# Planning Commission Work Session

January 31, 2023

# RZN22-0004 Glade Spring Crossing

**WATERS OF THE U.S.  
DELINEATION MAP  
CARY HOPPER**

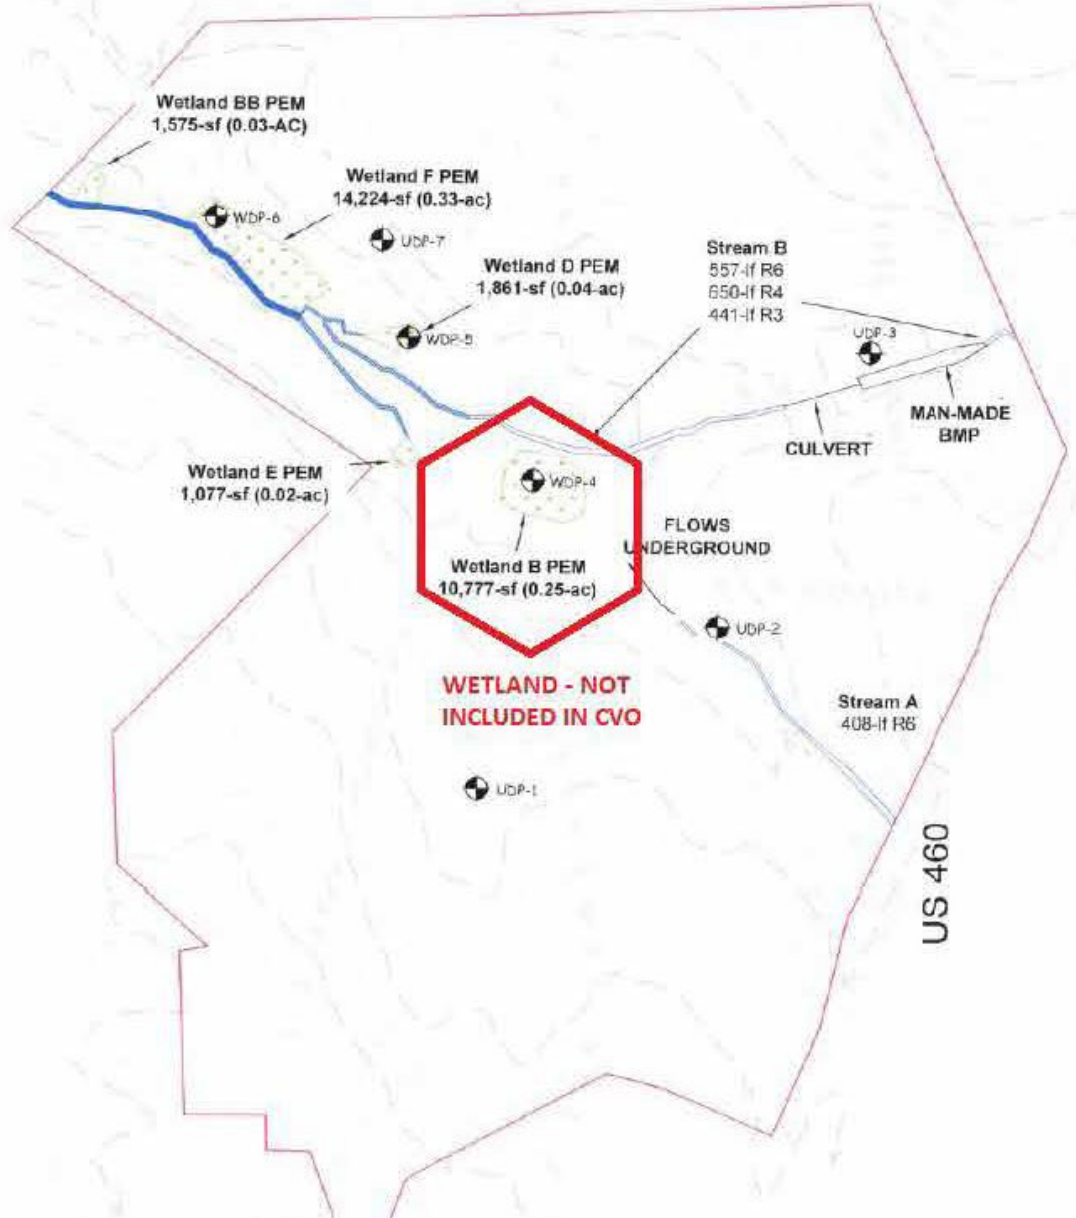
- Applicant requests to “redraw” CVO based on the geographical criteria in the ordinance
- Applicant’s request includes revised survey data showing 100-year floodplain; areas of 25% or greater slope; and revised map of US waters including wetlands
- Applicant will have to further revise the CVO boundary to include the wetlands identified by ECS

# Utility Separation Variance

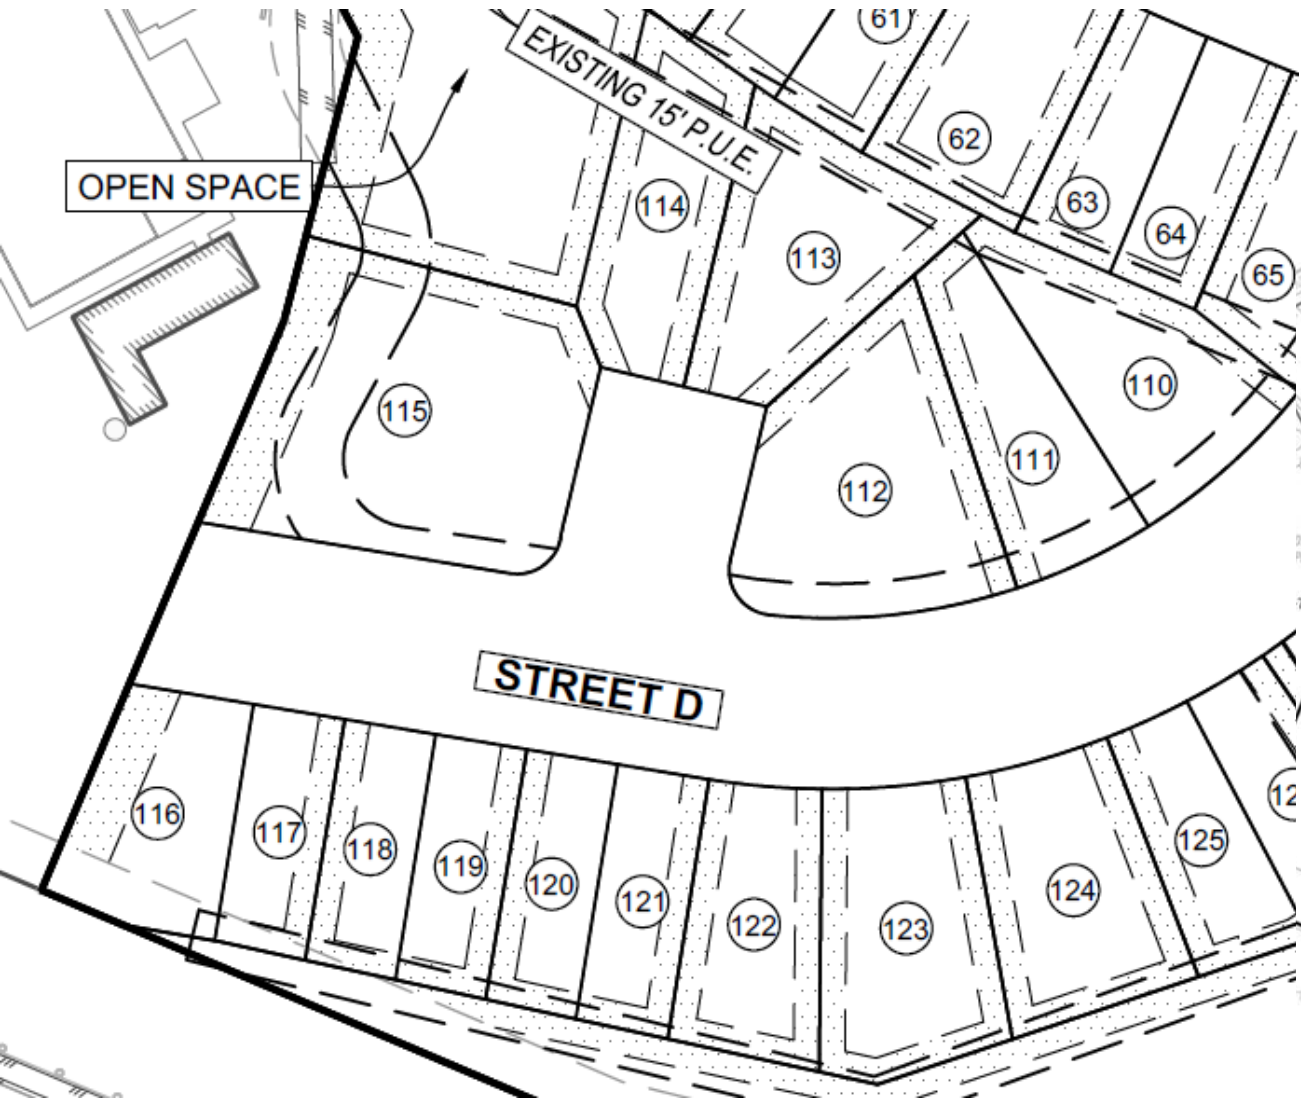
- Applicant requests to reduce minimum utility separation overall
- Variance may be appropriate in some locations, but a blanket approval is not appropriate

FIGURE B(1)-12 CULS-DE-SAC AND TURNAROUND DETAILS

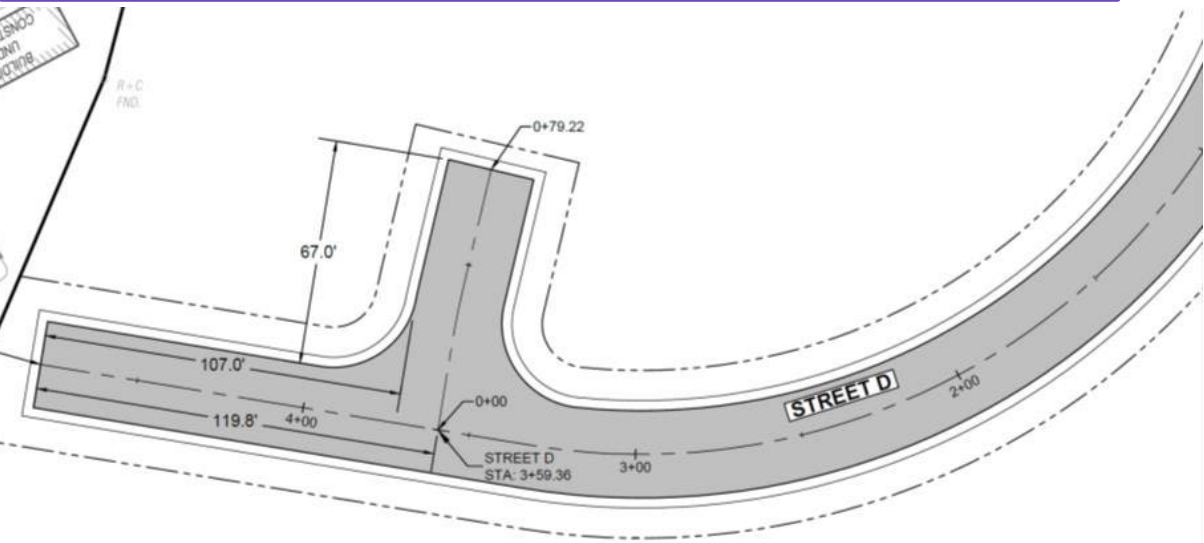
- Subdivision ordinance requires bulb cul-de-sac, but T or Y turnarounds may be approved by administrator or PC
- Applicant requests to construct a Branch turnaround instead of a bulb cul-de-sac
  - Branch turnaround is accepted by VDOT

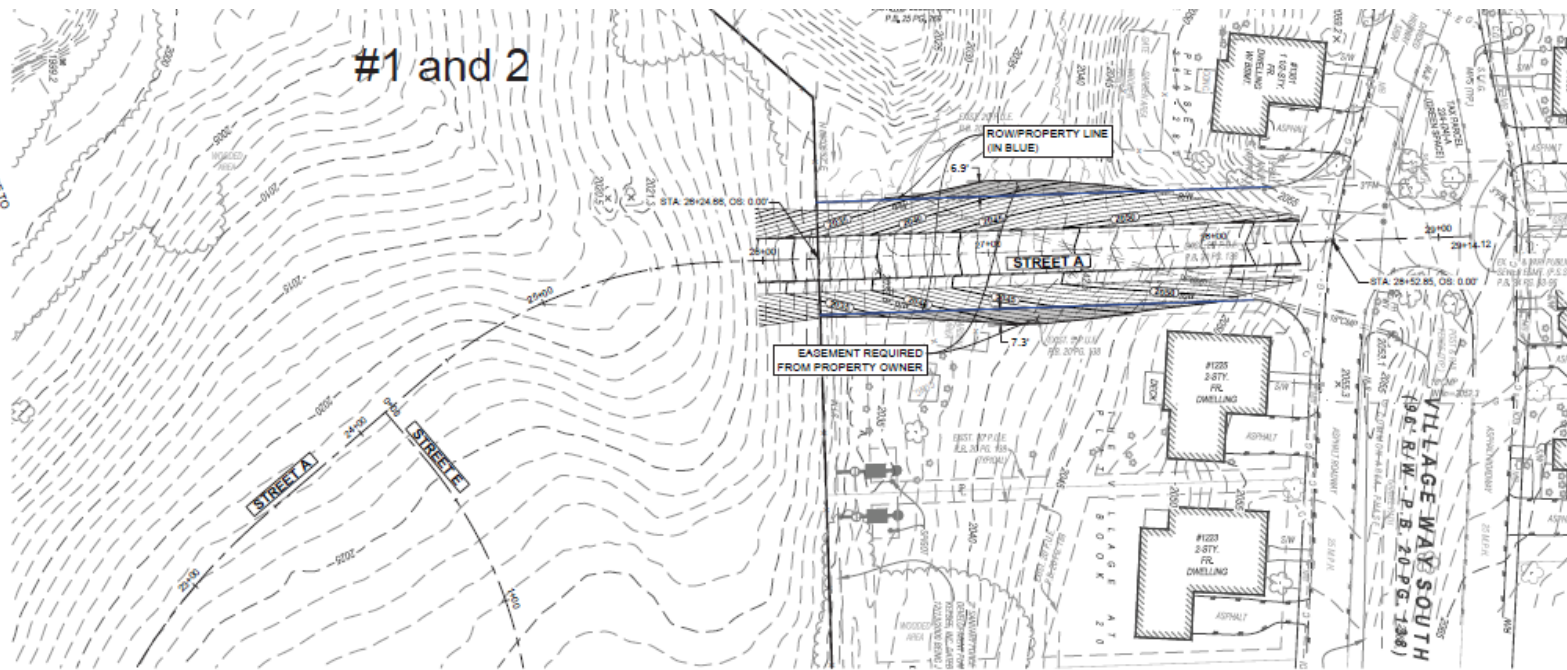
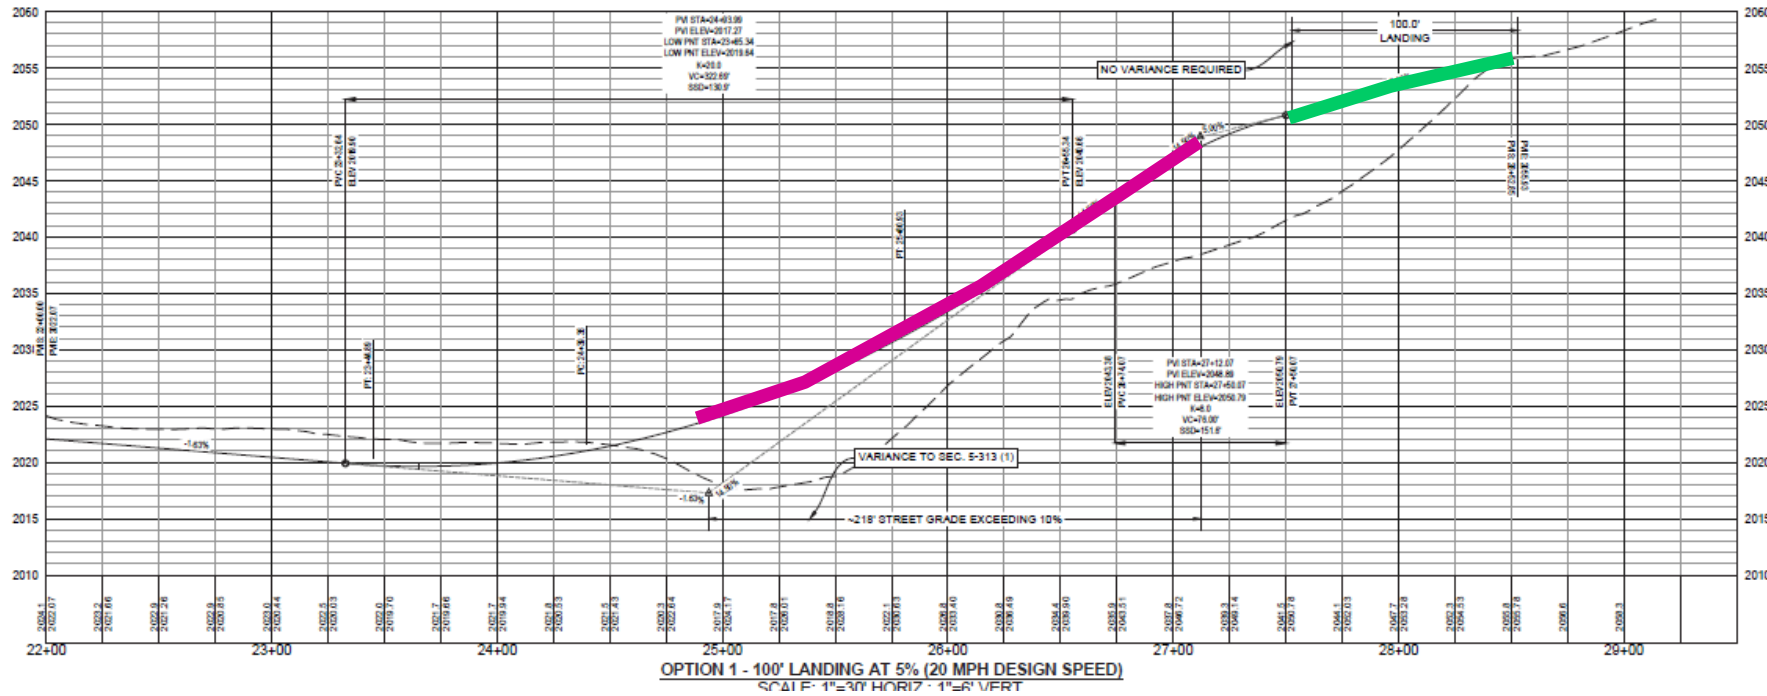
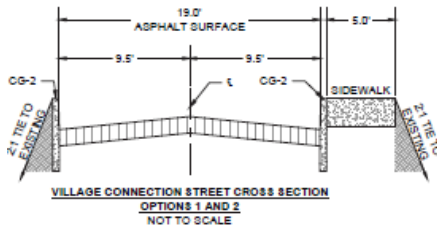
Includes sidewalk, no buffer

No variance for landing; variance for street grade required

#1 and 2

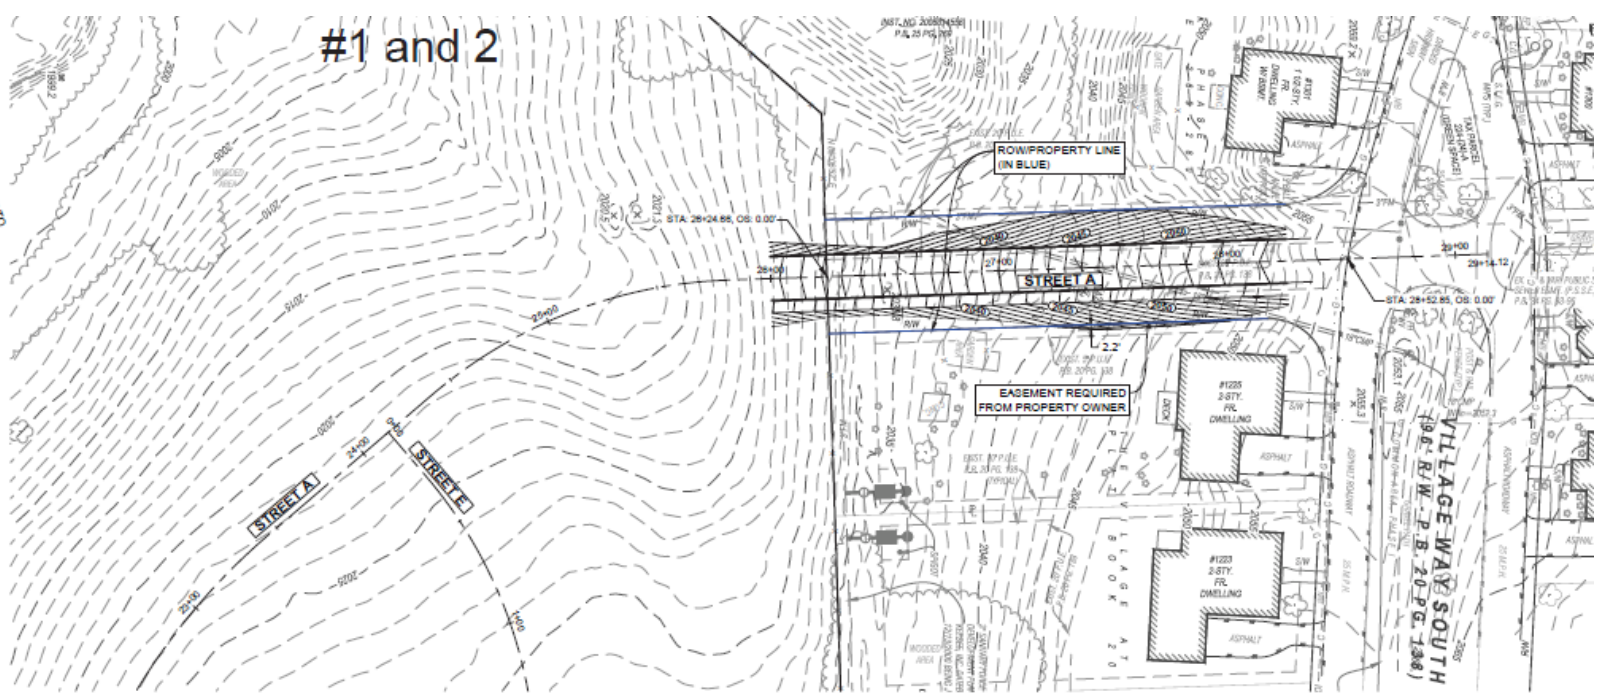
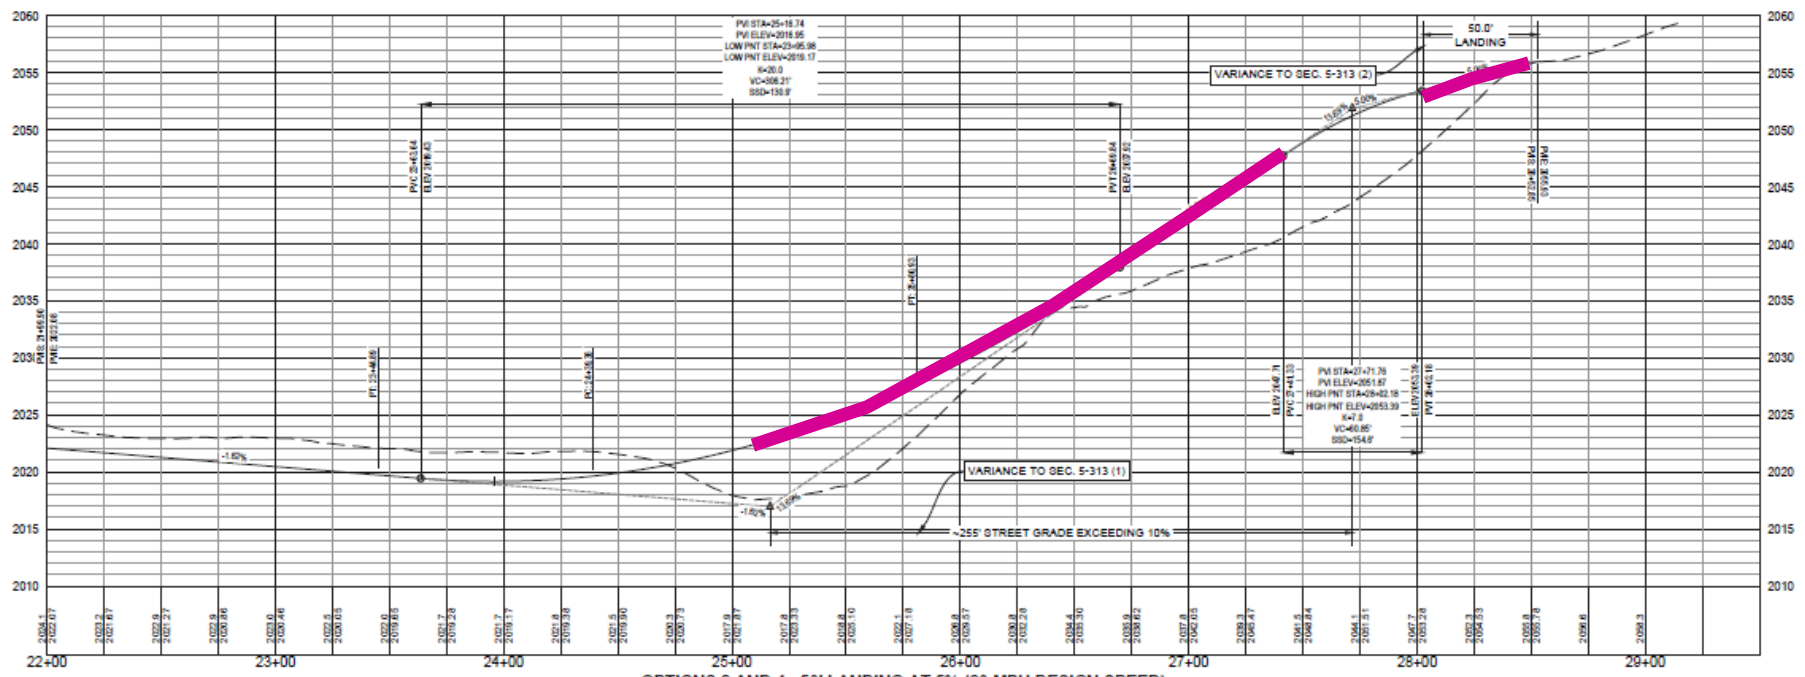
Includes sidewalk, no buffer

Variance for landing;  
 variance for street grade required

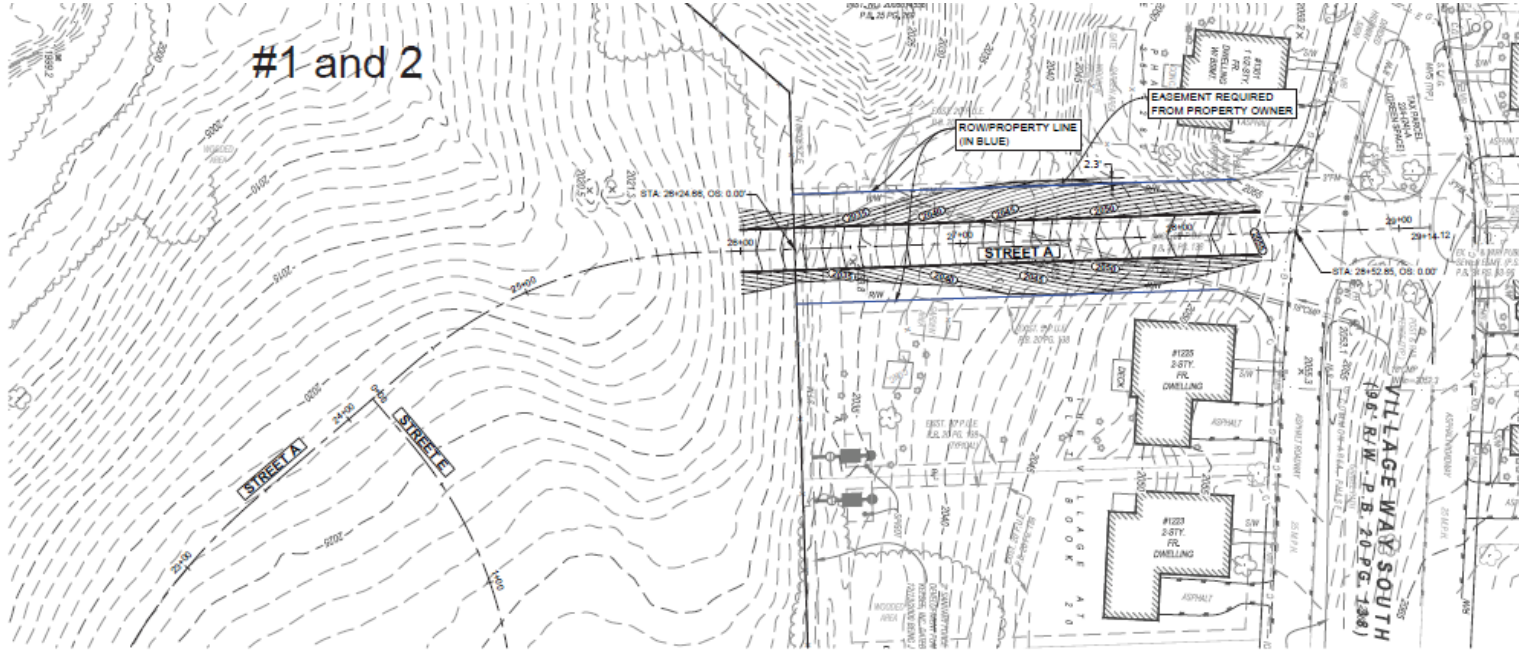
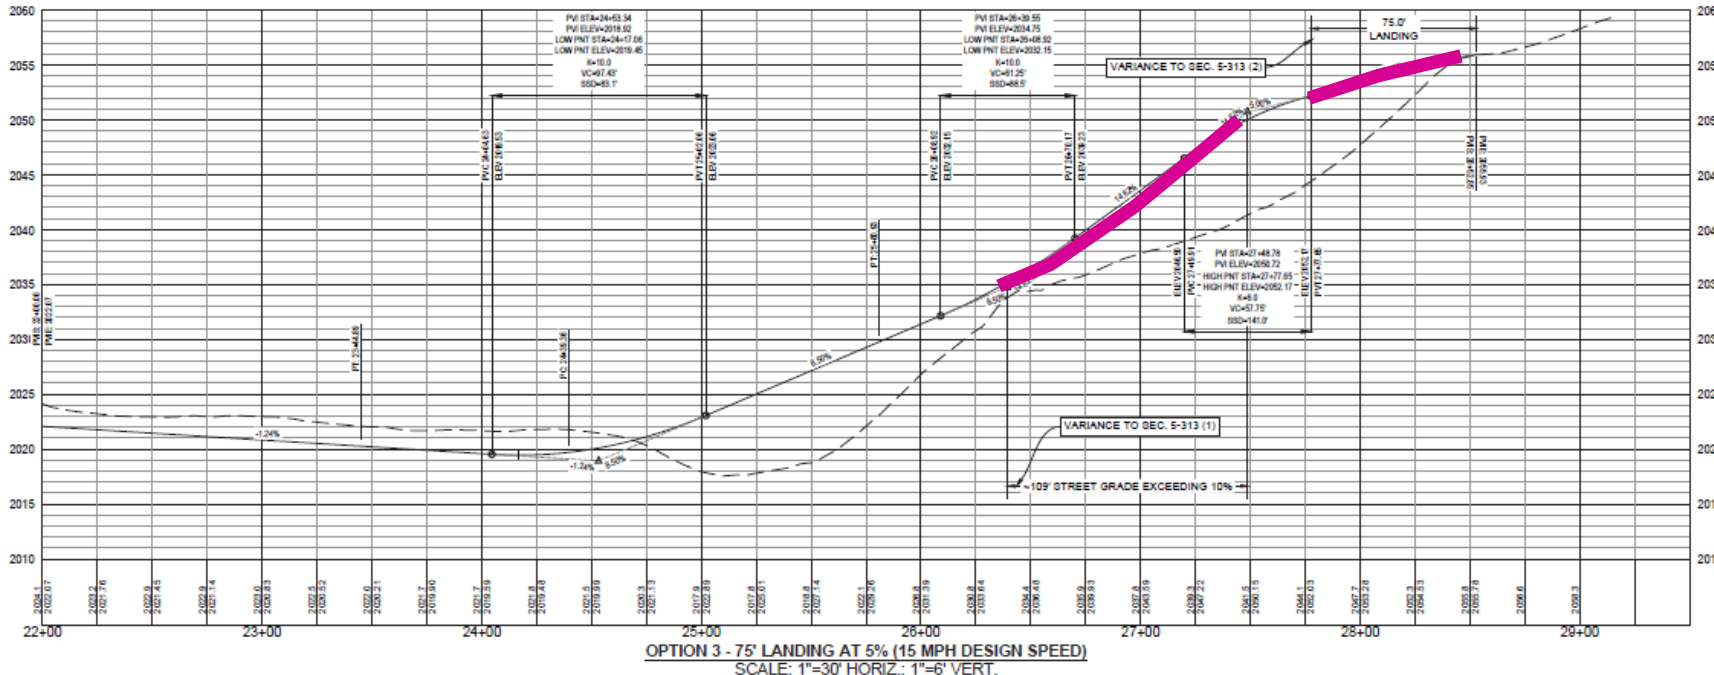
Does not include any accommodations for pedestrian connection

Variance for landing;  
 variance for street grade required
